Re: Docket Nos. 25-52-REG & 25-53-REG – The Narragansett Electric Company d/b/a Rhode Island Energy Renewable Energy Growth Program Year 2026-2027 and 2026-2027 Renewable Energy (RE) Growth Program Factor Filing Responses to PUC Data Requests – Set 1

The Narragansett Electric Company
d/b/a Rhode Island Energy
RIPUC Docket No. 25-52-REG
In Re: 2026-2027 Renewable Energy Growth Program and
RIPUC Docket No. 25-53-REG
In Re: 2026-2027 Renewable Energy Growth Program Factor Filing
Responses to Commission's First Set of Data Requests
Issued December 30, 2025

PUC 1-8, Page 3

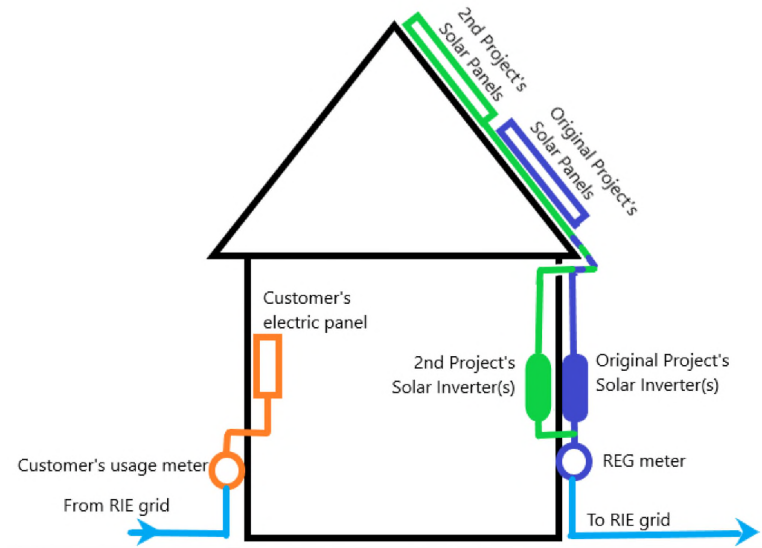
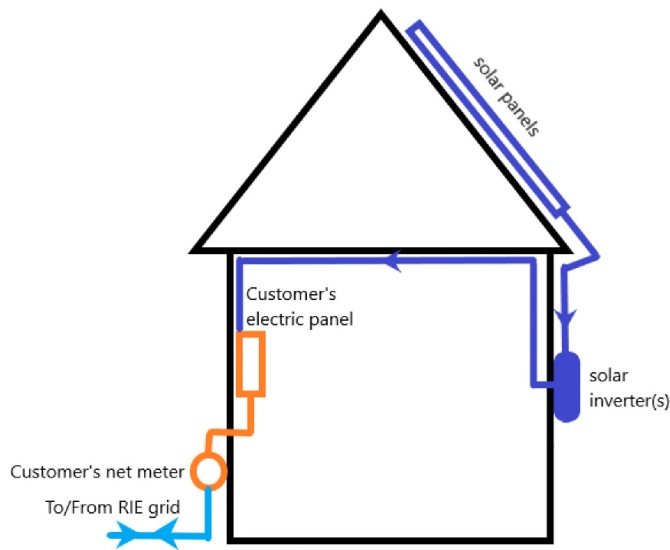
Page 14 of Gauntner's testimony states that "[s]ince the original project will continue generating energy but cannot independently qualify for net metering due to the shared meter, the Company suggests implementing a Post-Original Tariff Term ("POTT") PBI rate"

- a. Please explain the rationale for providing a PBI payment for a solar project after the expiration of its tariff term, including how the Company determined that an original solar project "cannot independently qualify for net metering" when sharing a meter with a second solar project.
- b. Please explain how the Company determined that an original solar project PBI should be reduced by 40% at the end of its tariff term, including any workpapers, data sources, and assumptions.
- c. Please explain any practical considerations that would prevent the Company from compensating an original solar project with Renewable Net Metering Credits at the end of its tariff term, rather than through a weighted-average PBI or Post-Original Tariff Term PBI.
- d. Does the Company plan to take title to all the RECs generated by an expanded facility during the Post-Original Tariff Term period?

- a. The customer's original system could independently qualify for net metering at the end of its tariff term. However, as the original solar project would be electrically joined with the second solar project, separating the two systems so that the original system independently qualifies for net metering would require substantial electrical wiring changes and, likely, a significant financial investment by the customer. Specifically, this would entail rewiring only the original solar project so that it connects to the customer's main breaker panel, thereby allowing the original solar project to offset the customer's own electric usage. The second solar project would also likely require modifications. These modifications are required for the original solar project to be independently metered and to be appropriately compensated under net metering.

If a customer intends for the original Renewable Energy Growth (“REG”) system to independently qualify for net metering upon the expiration of its tariff term while also seeking to install a second solar project under REG, the most direct approach would be to meter each REG system separately using two distinct REG meters. This approach is permissible under the current and proposed provisions of the REG program, provided that all project segmentation requirements are satisfied. Customers participating in REG with an active tariff term of 15- or 20-years are not eligible to transition to net metering until their current term has concluded.

The purpose of implementing a Post-Original Tariff Term rate is to ensure continued compensation for customers for the portion of the combined solar facility that remains operational following the expiration of its initial tariff term. Because the original and second solar projects are electrically interconnected, the original project's equipment will continue to produce electricity after its tariff term concludes. The associated RECs from the original project should, therefore, receive compensation. The Company recommends the use of the Post-Original Tariff Term Performance-Based Incentive (“PBI”) rate, which is designed to provide fair, but reduced, compensation for this ongoing generation.

For reference, an illustrative wiring diagram is provided for reference to depict the configuration of an original REG solar project in conjunction with a subsequent REG solar project. Although not explicitly illustrated, this configuration could also accommodate a shared inverter and/or shared wiring or conduits. A comparative illustrative wiring diagram for a net-metered system is included to clearly demonstrate the differences between these configurations.
